PROPOSED OPENING WITHIN PARTY WALL BETWEEN UNITS 10 AND 11, 1114 PITTWATER RD COLLAROY

We have reviewed the proposed alterations to units 10 and 11.

Part plan of original structural drawings. Colour annotations by JTA. Not to scale.

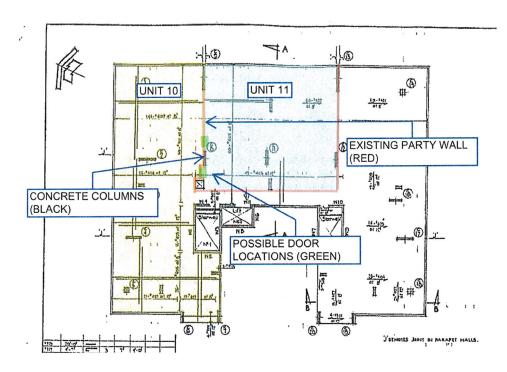
You have advised that you wish to create an opening in the masonry common wall between units 10 and 11 at the above address. The proposed opening is 1200mm wide and located entirely within the infill masonry wall. There is no proposal to remove any load bearing concrete column. Refer annotated plan below showing 2 locations discussed.

Although the masonry walls are designed as non load bearing, given the age of the building it is possible that some long term creep deflection may be resisted to varying degrees by some of the internal masonry walls. Where this occurs it is possible that removal of long sections of wall may release some of this long term creep deflection.

However, given the limited width of the proposed opening (1200mm) and the proposed location (close to a supporting column) it is very unlikely that any such deflection would be released by the construction of the proposed opening between units.

Both unit 11 and 10 are separate fire compartments within the building. Linking these two via an opening alters the fire compartment size.

The column located within the fire separating wall between units 10 and 11 is the same thickness as other columns within the building that sit entirely within a fire compartment. From a structural point of view we see no barrier to the introduction of a 1200mm wide door within the non load bearing masonry between the units 10 and 11.
